SUBJECT: SEABROOK STATION, UNIT NO. 1 – INTEGRATED INSPECTION REPORT  
05000443/2021004

Report Number: 05000443/2021004

Facility: Seabrook Station, Unit No. 1

**Figure 1: Reactor cavity pit overhead view**

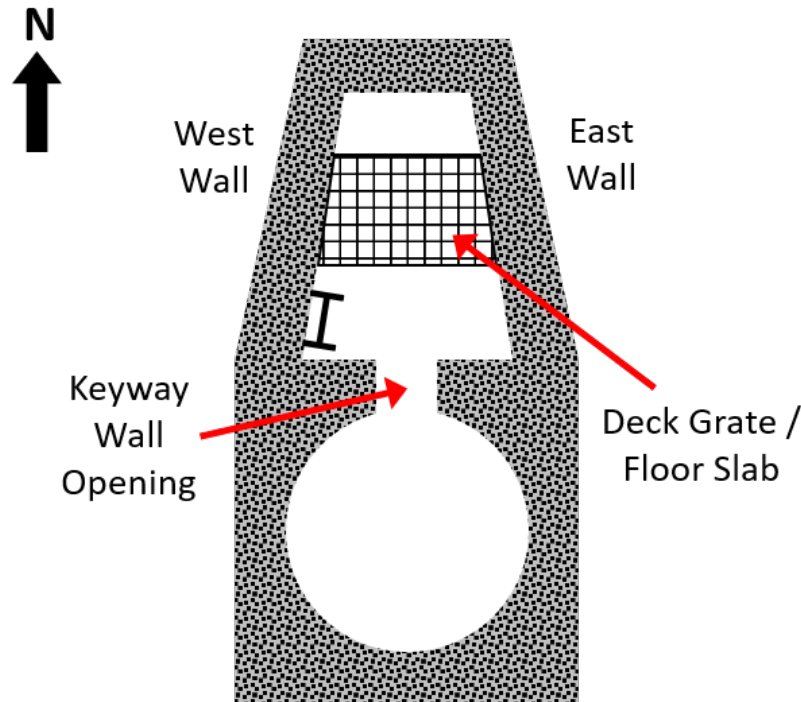
observed deformation of the metal deck grating (exhibiting ~1" of vertical bowing) adjacent to the spalled floor slab. The inspectors determined that this deformed deck grating and crack in the East keyway wall opening, while present in photographs from 2017, had not been documented or evaluated by NextEra in walkdown reports or subject to evaluation.

The inspectors noted that the deformation of the metal deck grating as well as the crack in the East keyway wall opening met the criteria for "unacceptable" in the Structures Monitoring Program (passive settlement or deflections outside of original design limits and passive cracks more than 0.04" in maximum width) and should have been documented and included in the evaluations conducted as a result of the 2017 field inspections.

evaluation. Two of the “likely” criteria for visible features suggestive of ASR include “structure shows symptoms of increase in concrete volume leading to concrete spalling, displacement, and misalignment of elements” and “extensive map cracking or pattern cracking aligned with major reinforcement or stress.” The inspectors determined that the observed series of horizontal flexural type cracking on the East side wall of the North extension area, the spalling of the floor slab cover concrete and bowing of the adjacent metal deck grate of the North extension area floor slab, as well as the horizontal/circumferential cracks observed on the East and West keyway wall openings met these “likely” criteria and were suggestive of possible ASR-induced building deformation. Per the Structures Monitoring Program ASR methodology document, an evaluation of the impacted areas of the CIS structure should have been conducted which would have included additional ASR load demands for comparison to the total structural load in accordance with the code of record, ACI 318-71, to ensure that the structure remained in compliance with the design code of record. The inspectors determined that the failure to document unacceptable structural deficiencies observable during field inspections in 2017 and 2018 and the failure to subsequently conduct an evaluation of added load demands from potential ASR-related building deformation was a performance deficiency.

Corrective Actions: After discussions with NextEra, a condition report was generated committing to the performance of a Stage 2 ASR-related structural evaluation per the Structures Monitoring Program methodology document as well as enhanced monitoring of the structural indications observed in the reactor cavity pit area. Additionally, NextEra generated an Operability Determination for the CIS. The Operability Determination assumed a reasonable ASR expansion in the reactor cavity pit walls, reactor shield walls, and containment foundation based on the indications observed. The Operability Determination applied the load from this expansion on the impacted structures and demonstrated that, when cracked section properties were considered (as allowed by the approved Structures Monitoring Program), the additional estimated load could be accommodated within the existing margin of the structures. NRC inspectors, including inspectors from the regional office and headquarters, reviewed the Operability Determination and determined that there was sufficient technical rigor to support NextEra's conclusions that the structure remained capable of performing its safety function. The inspectors noted that a more detailed finite element analysis was underway in accordance with the Seabrook Structures Monitoring Program methodology document.
